## Appendix 17: Record of meeting with Selwyn District Council

**Meeting Minutes:** Selwyn District Plan Review - Trices Road Rezoning Group Submission

Location: SDC Rolleston

Date: 20/8/20

ROAD CROSS SECTION 22/10 - N/S

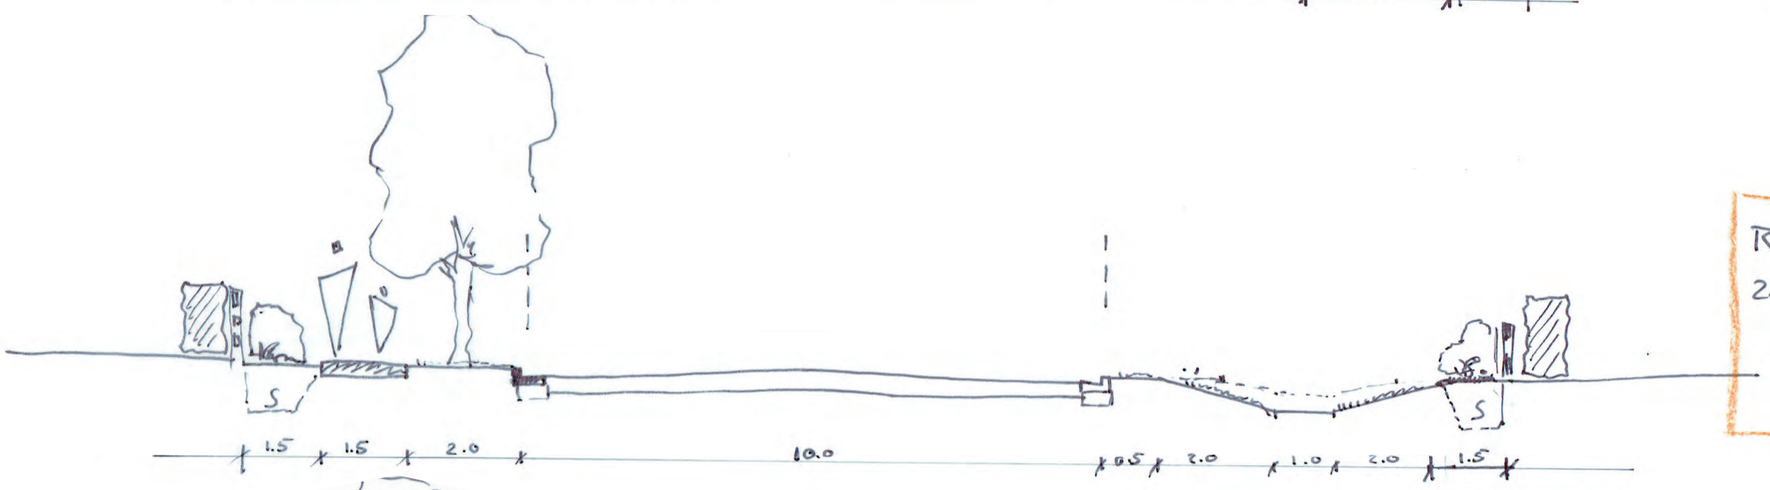
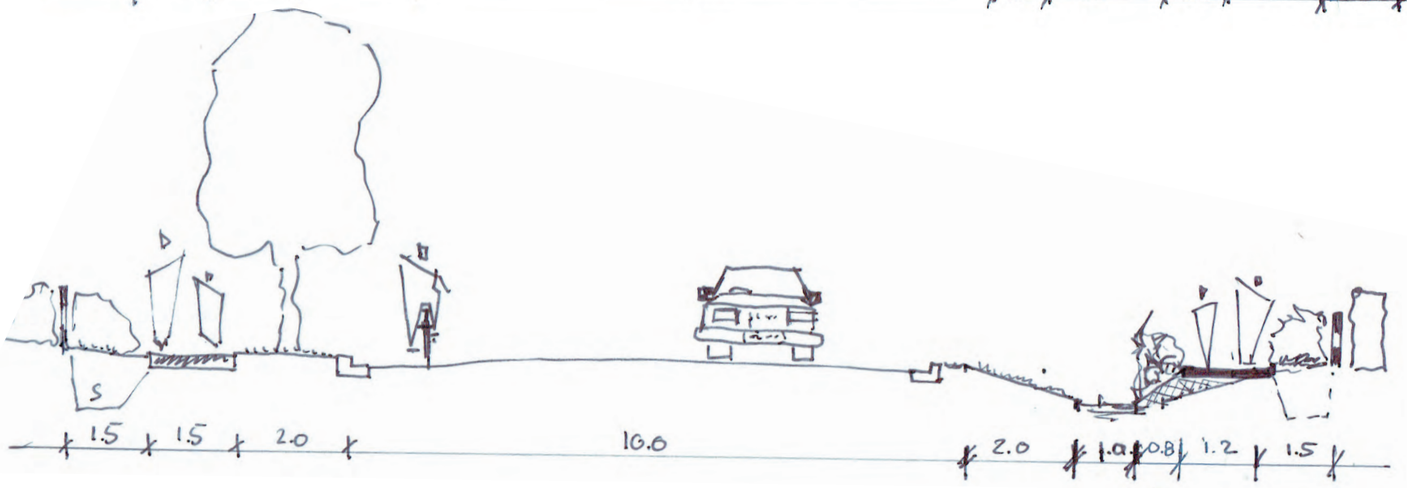
AM –design should make provision for potential future road linkages (2) to east. RR development should have footpath on one side of the road. Residential – footpath both sides for the primary road network. Hamptons, Birchs and Trices Road need to be upgraded but not to same extent if RR. Seal and provide footpath for RR For full residential requires kerb & channel and street lighting.

Don't favour 'scrunching' swales for full residential. Require kerb & channel. Also driveway crossing is an issue for urban development with swales. In SDC's experience, swales may not be maintained properly by the developer which leads to complaints.

ROAD CROSS SECTION 20/8

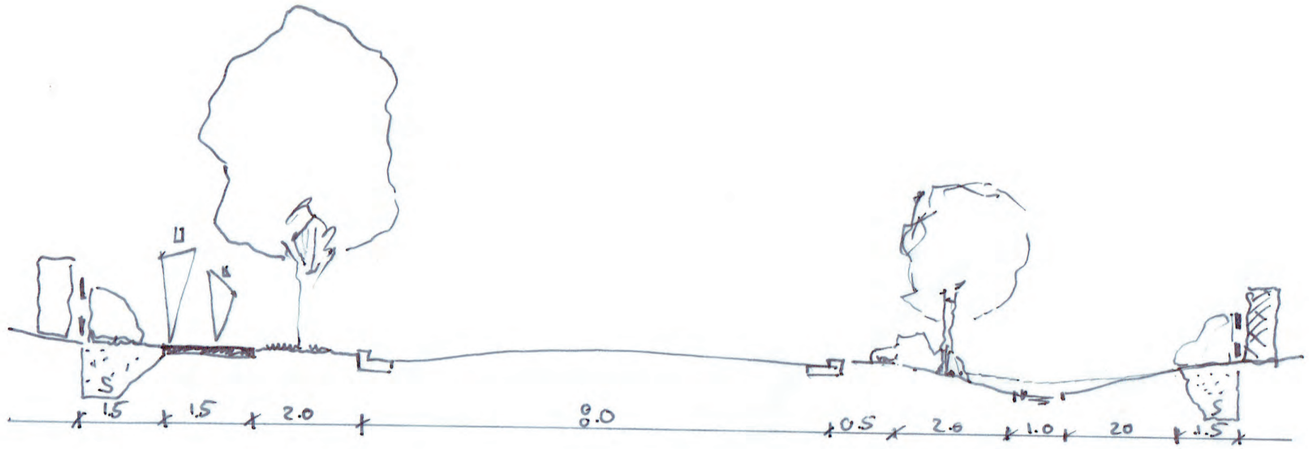
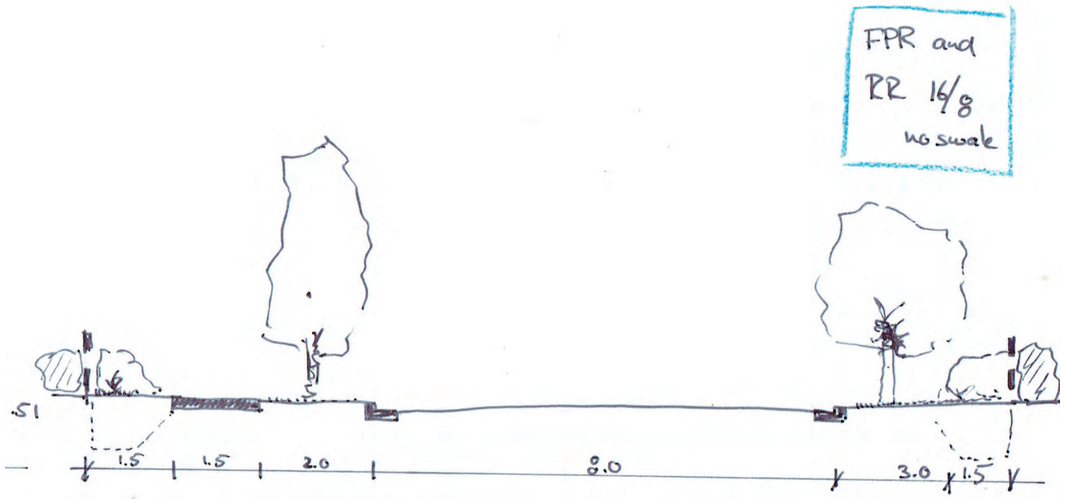
GB – placement of wheelie bins can also be problematic with swales.
